Visual Impact Statement

The purpose of the Landscape and Visual Impact Assessment (LVIA) to assess the visual impact of the proposed scheme on local residents.

Hilltop Action Group

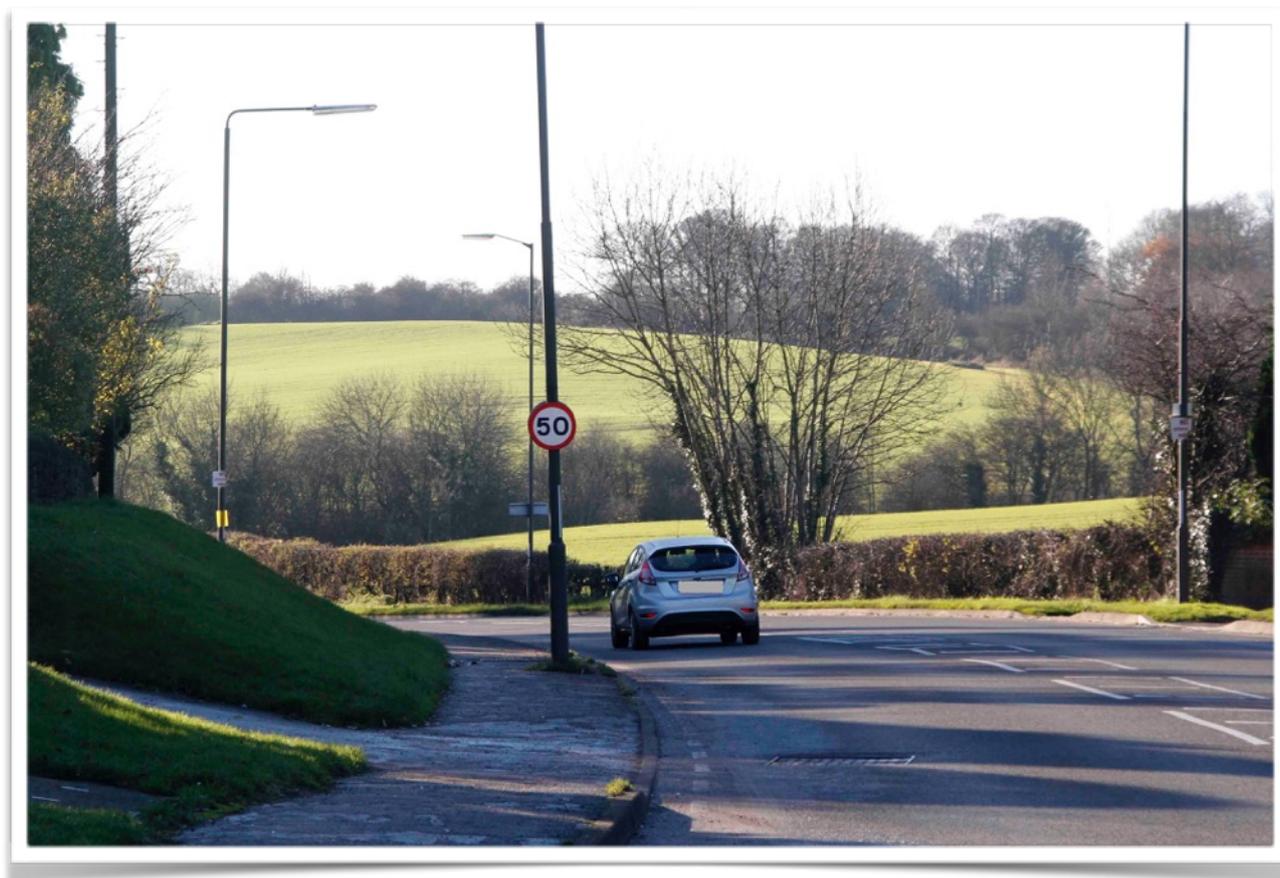
This advice appears to have been largely ignored as no views from the site have been provided nor has any attempt been made to quantify the number of properties having a particular view of the Hilltop site.

We leave it to the applicant to provide this information.
